Ventura County Community College District

DATE: 04/17/26
TO: All Bidders
FROM: David Cienfuegos, Purchasing Specialist
SUBJECT: Addendum 1 – Bid 726 Moorpark College TB-210 CNSE & Accounting
Computer Classroom Electrical/Data Modifications

Attached please find revised mechanical plans 25-196 Moorpark College Tech Building Room Revised Addendum A T-21004-16-26

PROJECT TITLE AND SCHOOL LOCATION
TECH BUILDING ROOM T-210 COMPUTER ROOM UPGRADE
 7075 CAMPUS ROAD
 MOORPARK, CA 91320

SHEET TITLE:
NEW WORK SECOND LEVEL POWER PLAN ROOM 210

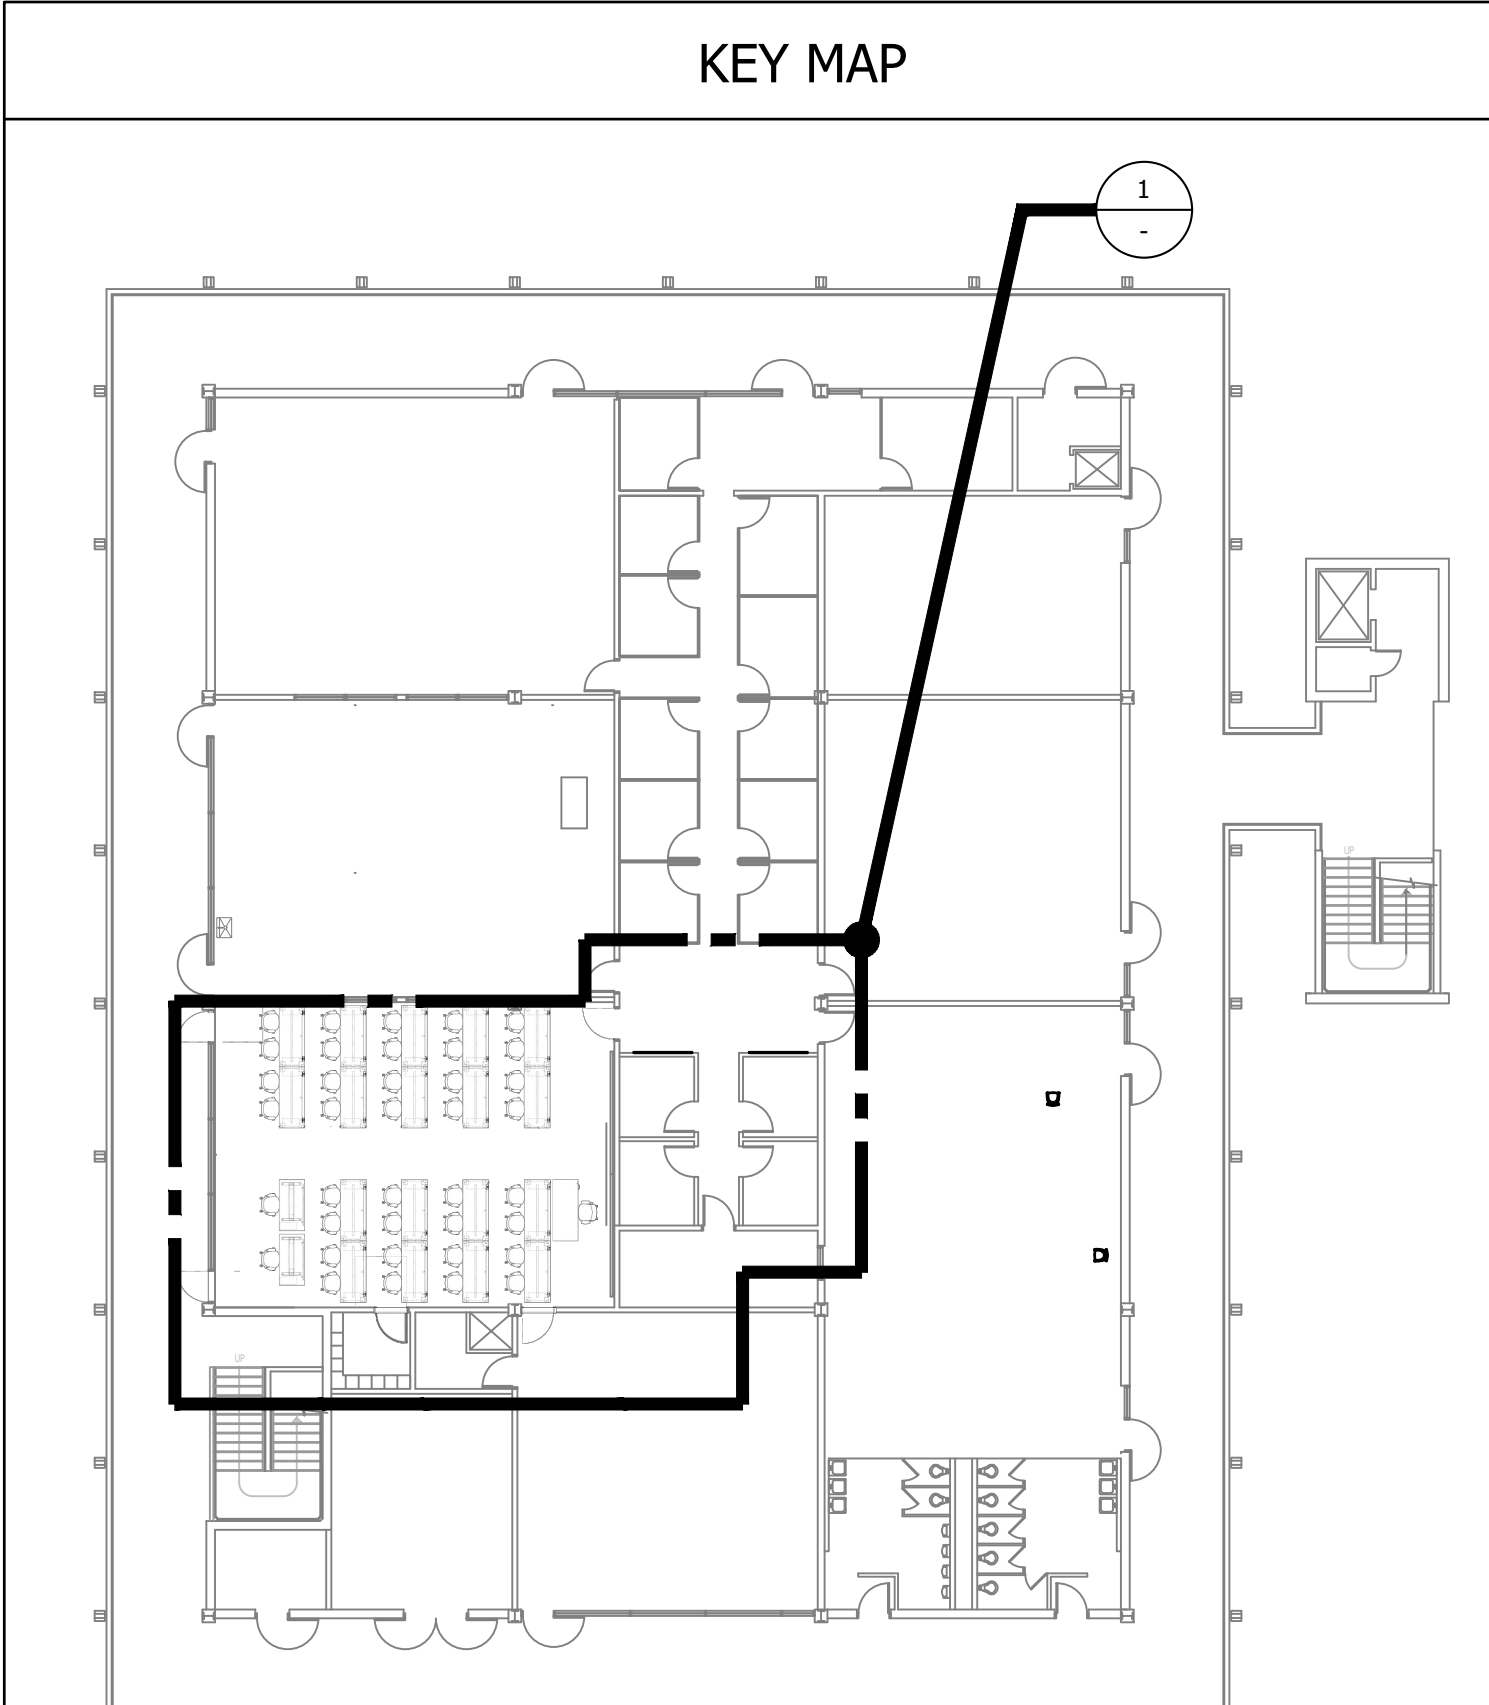
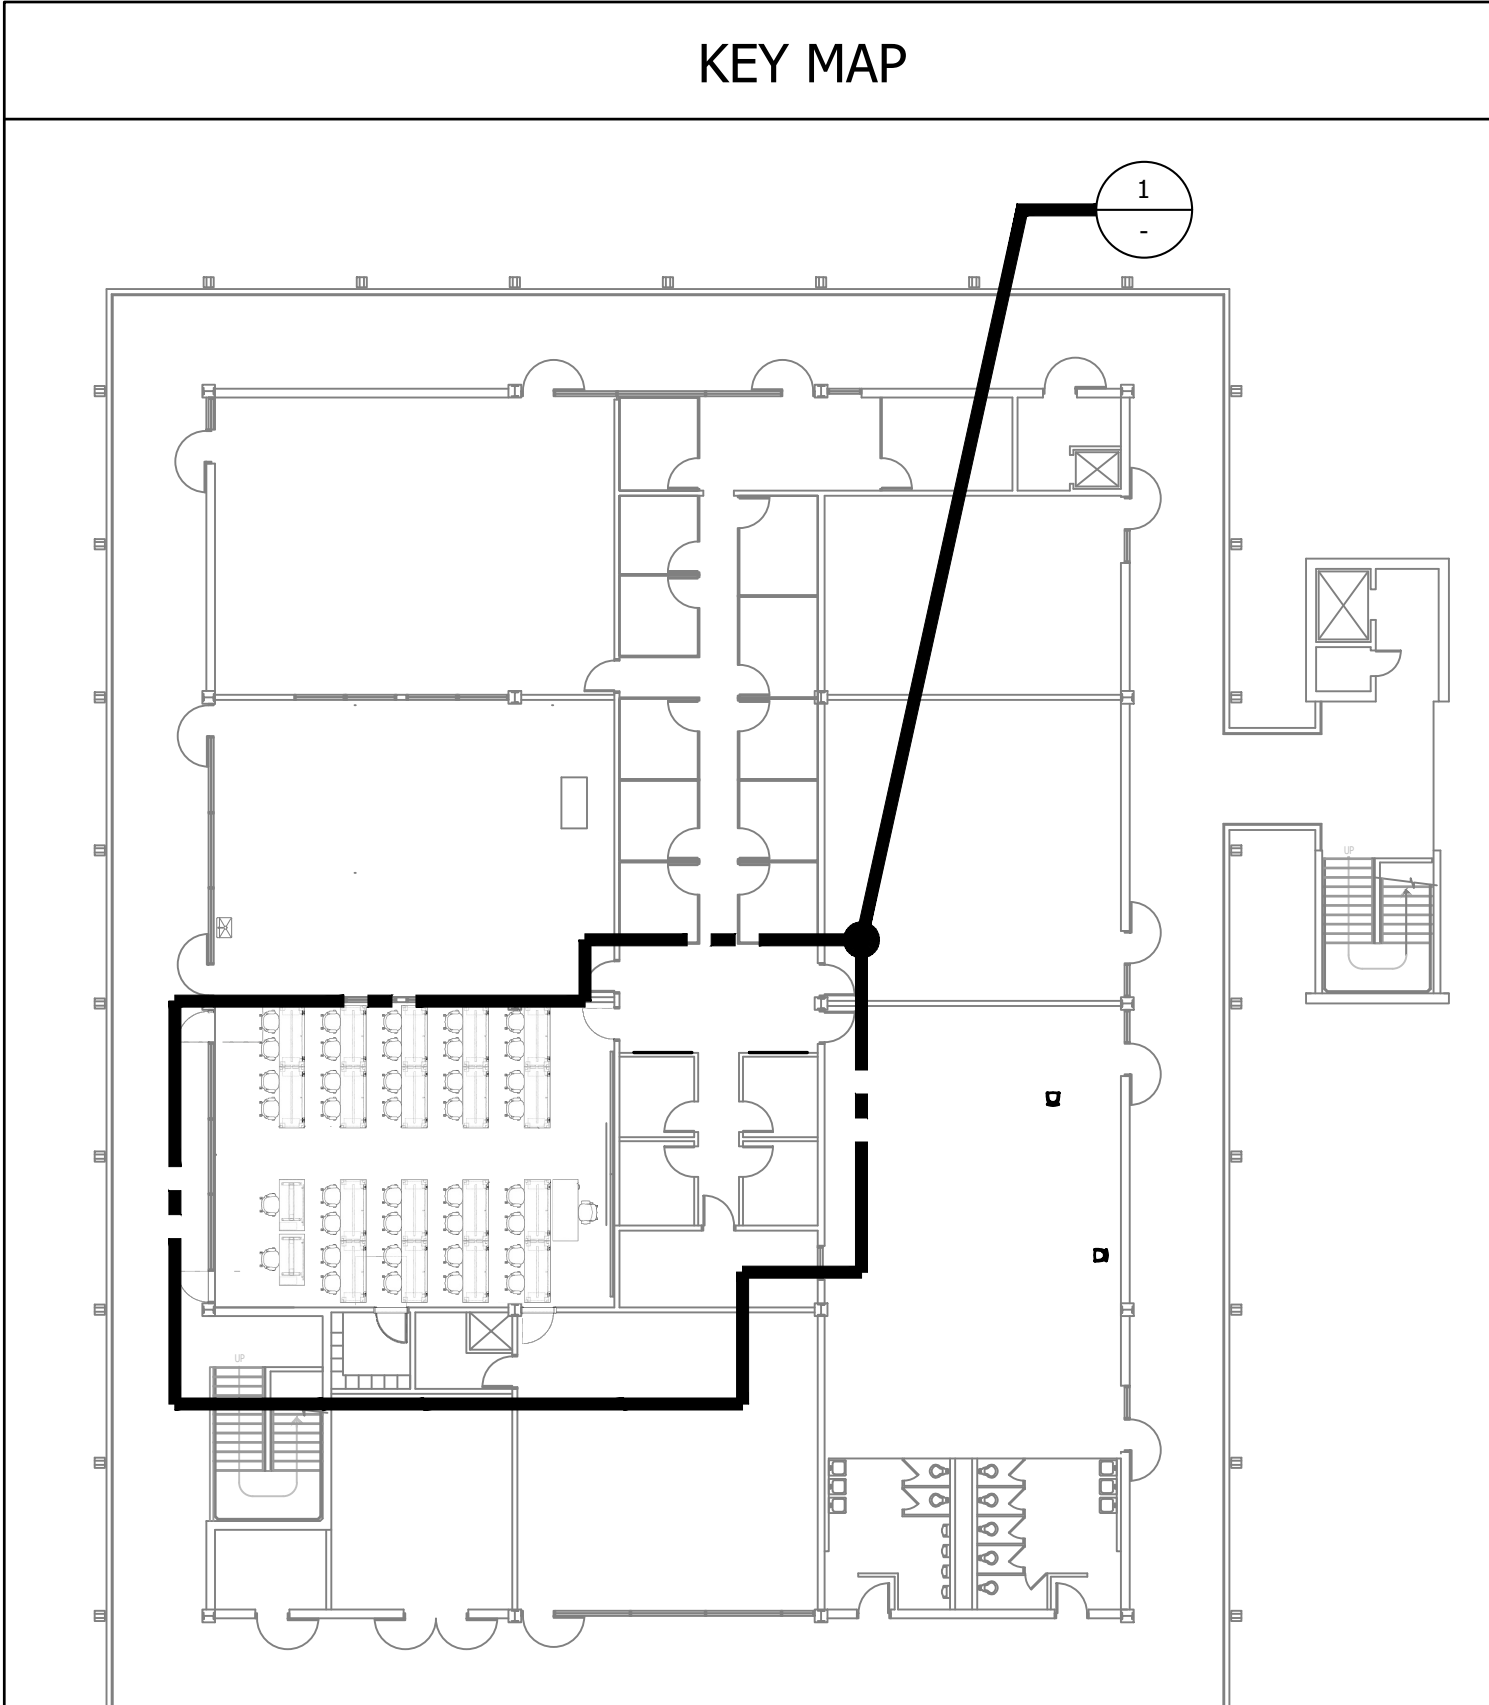
1. Contractor to provide furniture for work stations?
 - a. No, Campus will provide furniture for the work stations.
2. For core drilling, will an x-ray be required and is contractor to provide?
 - a. Xray all of the coring locations is required and to be performed by the awarded bidder.
3. Data/Power outlet for Printers by instructor's desk?
 - a. Please see the updated plans attached.
4. Communication room on 2nd floor?

ONLY COM CONDUIT REQUIRED IS IN VISIBLE SPACE IN ROOM, ALL ABOVE CEILING CABLING SHALL BE RUN ON J-HOOKS.
